I have run across some modeling inconsistencies between the 2013 and 2014 posted short circuit cases.

Attached are screenshot examples, the differences range from bus number changes from ERCOTs 160XXX range to AEPs 80XXX range, the number of generators at the site, the amount of generation of a particular site, GSU impedance values changing, generator source impedance changing, and current limiting of generators changing among other discrepancies.

2015 case from the 2014 build 1L-G fault @ bus 160294

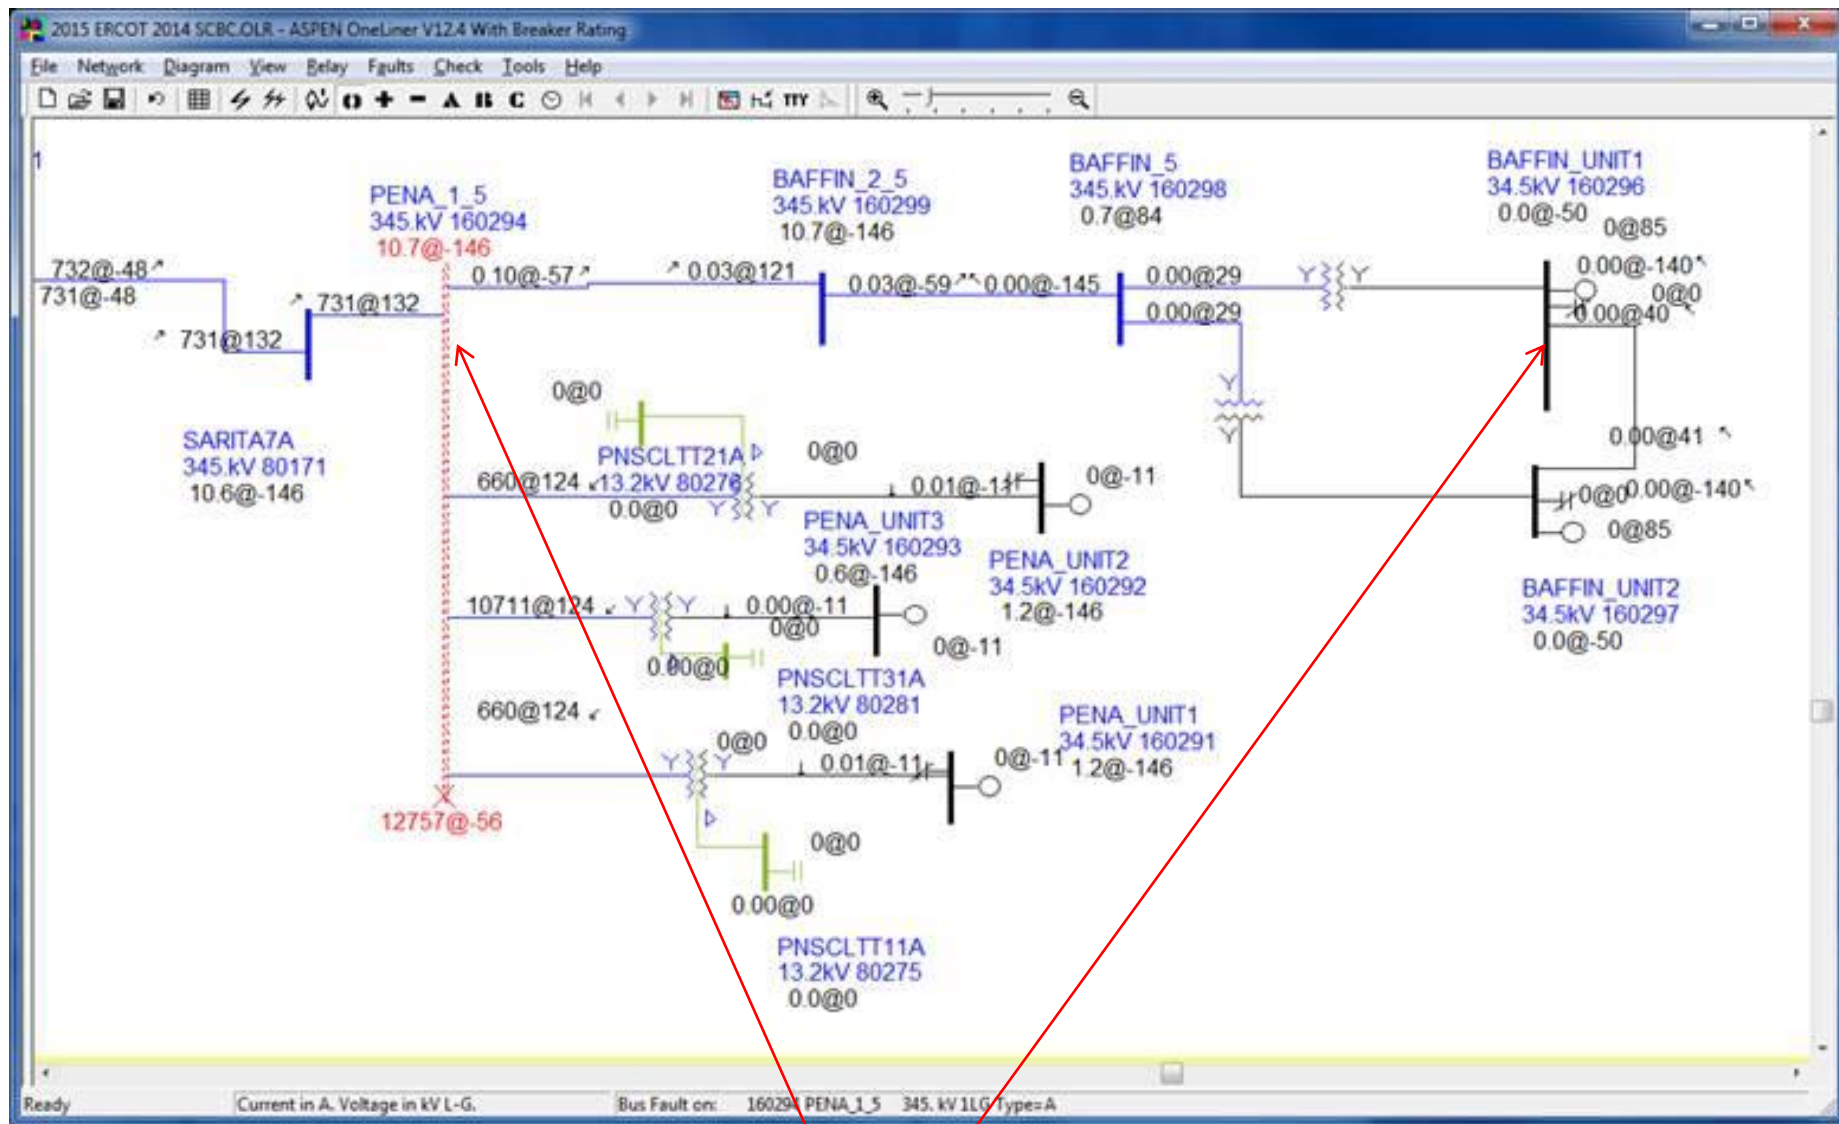
Comment: 13% increase in current. PENA_UNITx – 586/586/9512 vs 665/665/10782

2015 case from the 2013 build 1L-G fault @ bus 160294 of correction to Baffin transformer

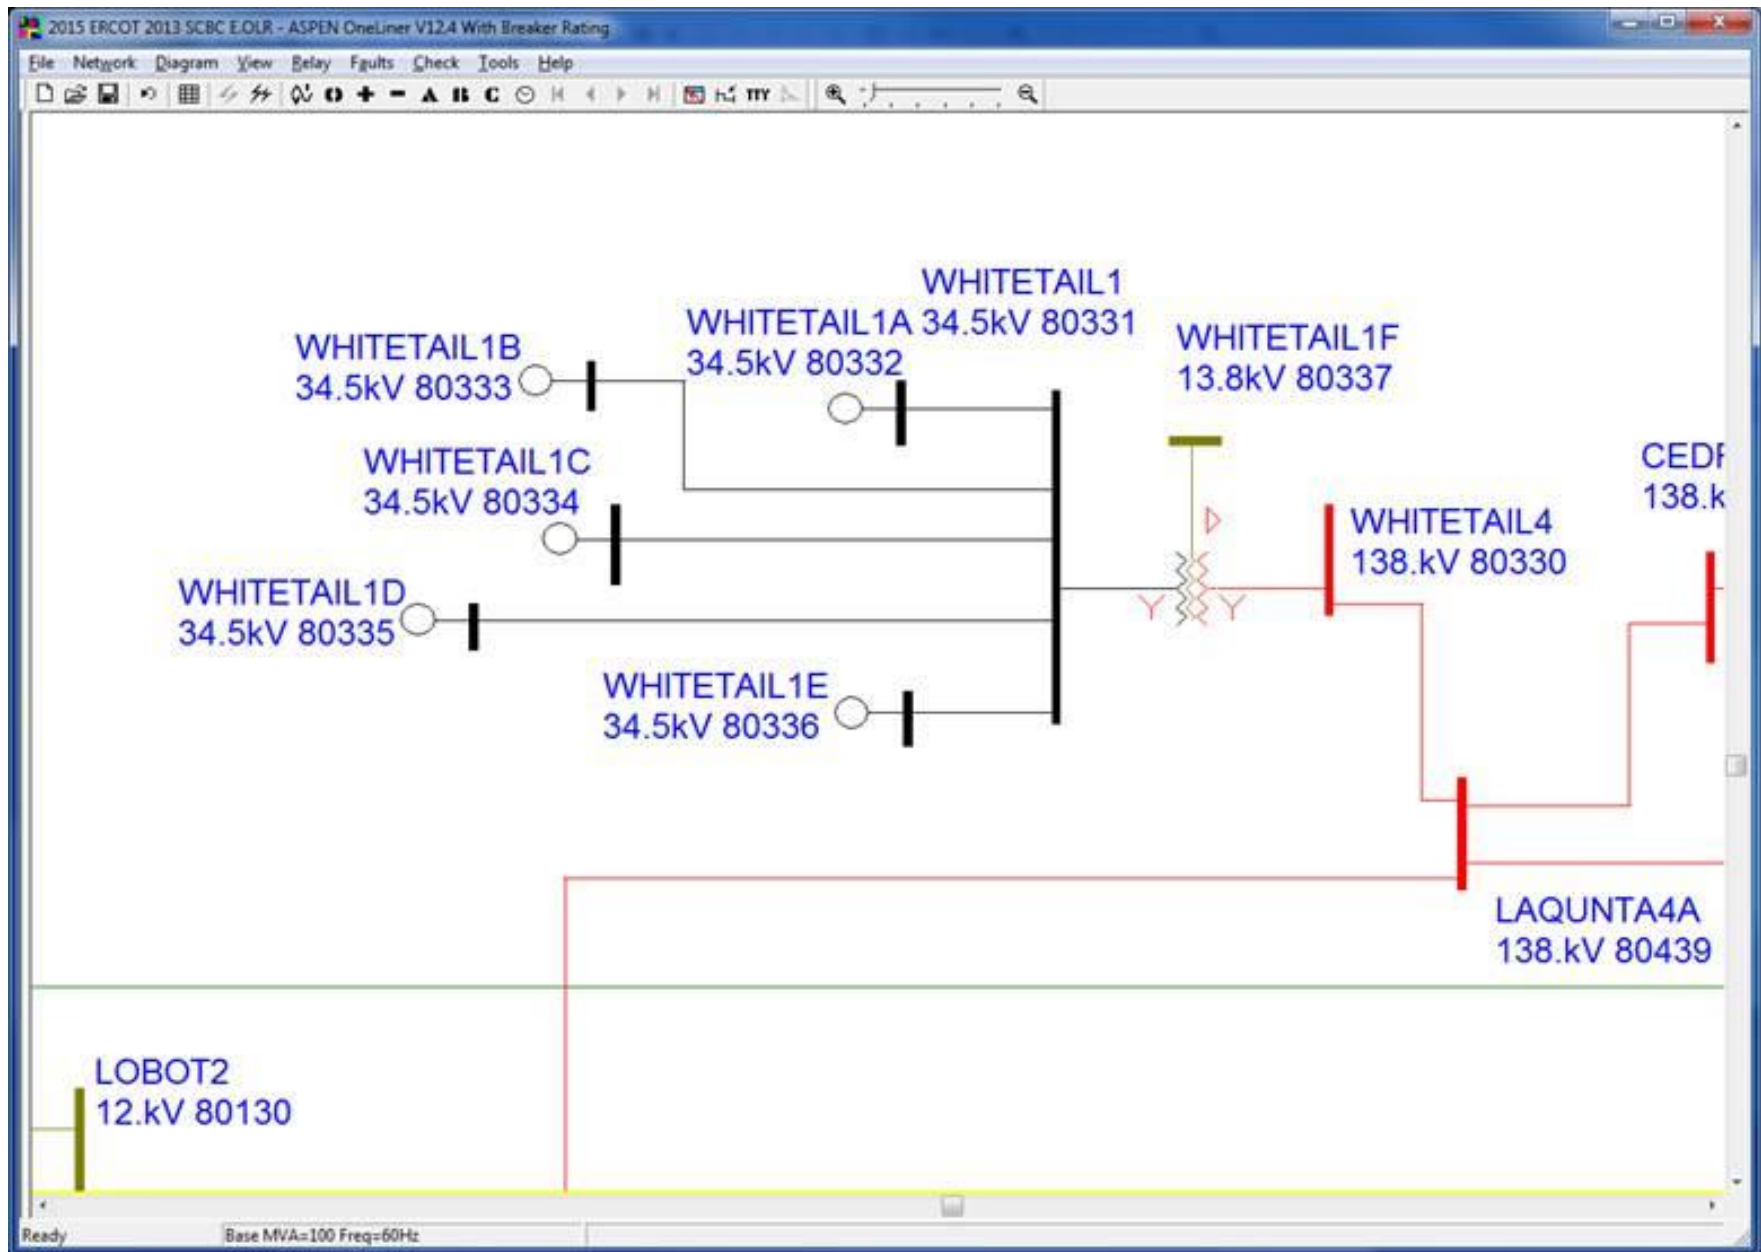
Q: Where is the PENA-BAFFIN delta-wye transformer? What is the correction?

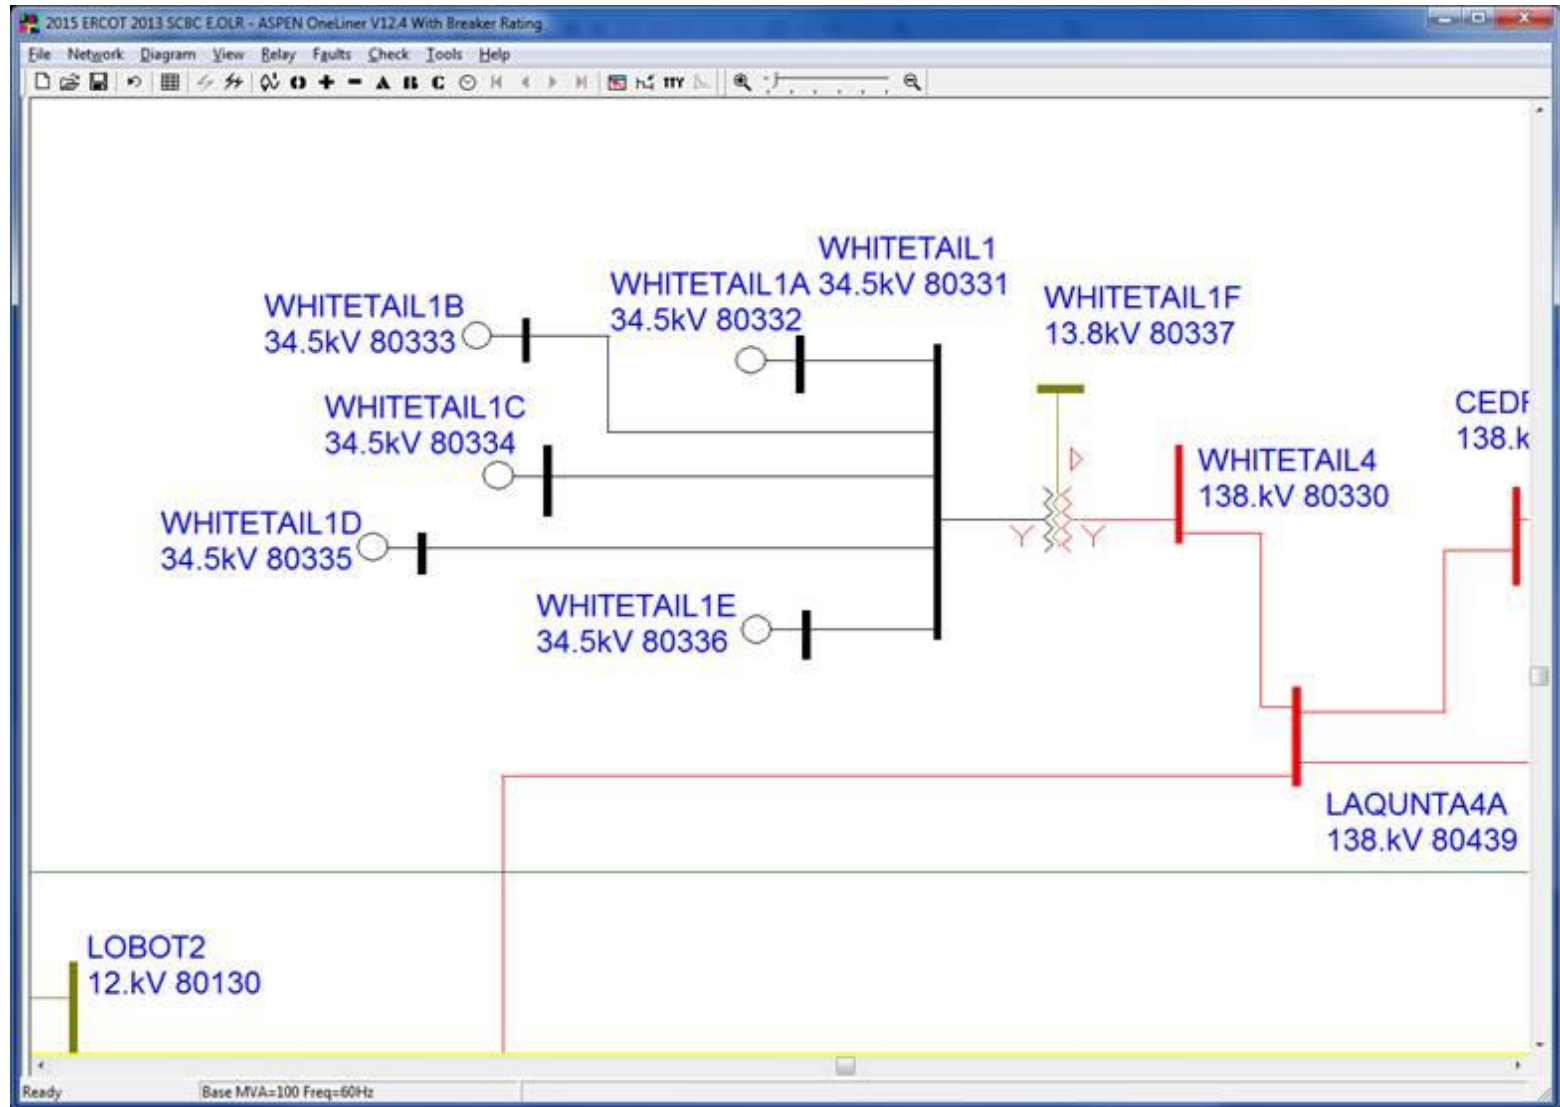
Whitetail wind farm should Have Names and numbers in the 908 area range not in area 8 range

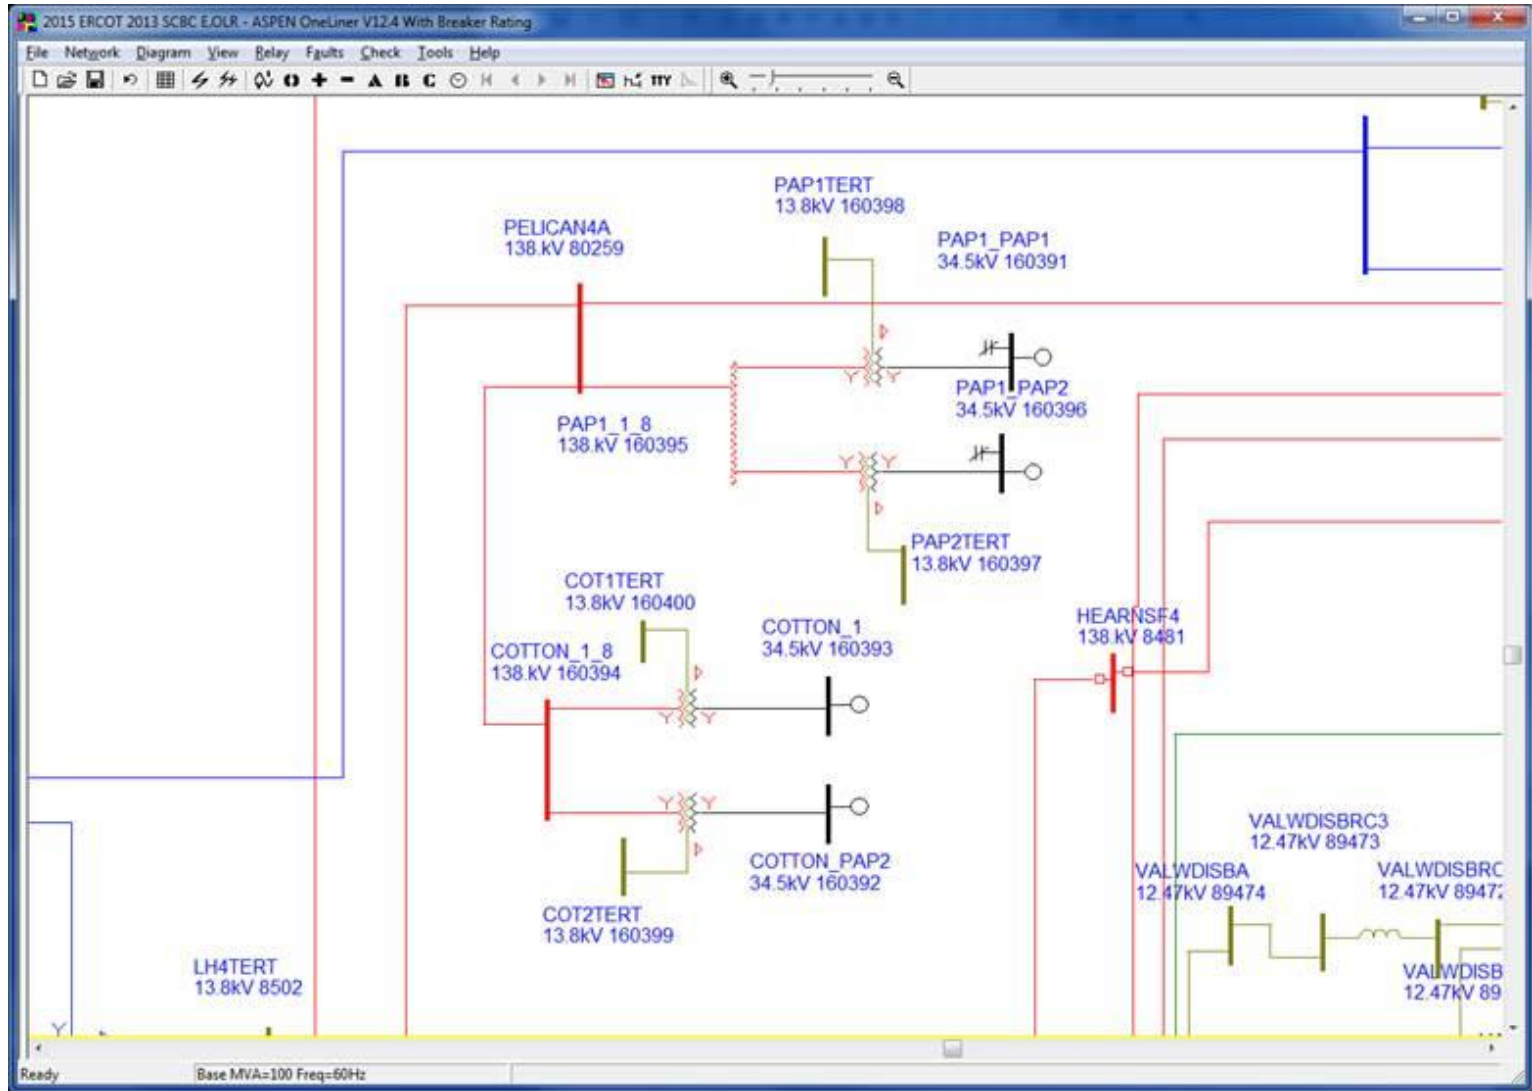
Missing connection to WHITETAIL 1B 80333 (still needed ERCOT name and number)

Q: What connection is missing? In 2014 Final, I see 1B to Whitetail1.

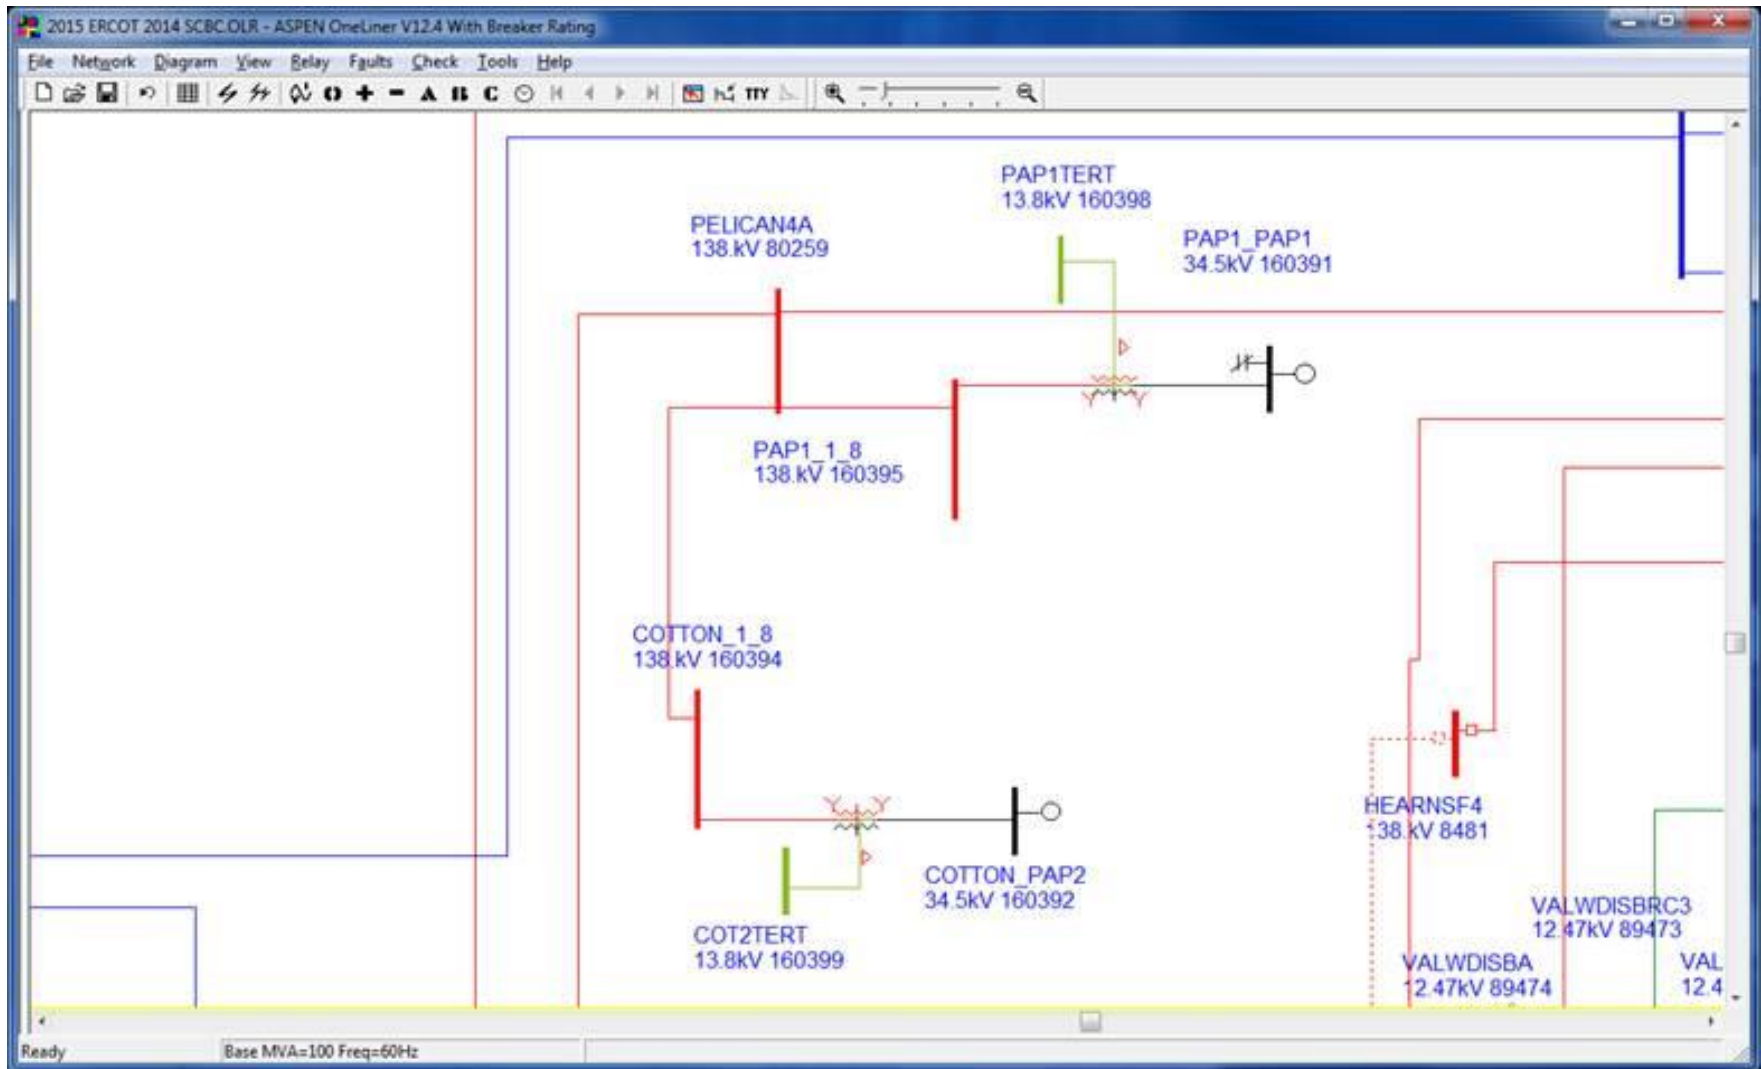
Papalote and Cotton wind farms this is the correct model as to total number of farms
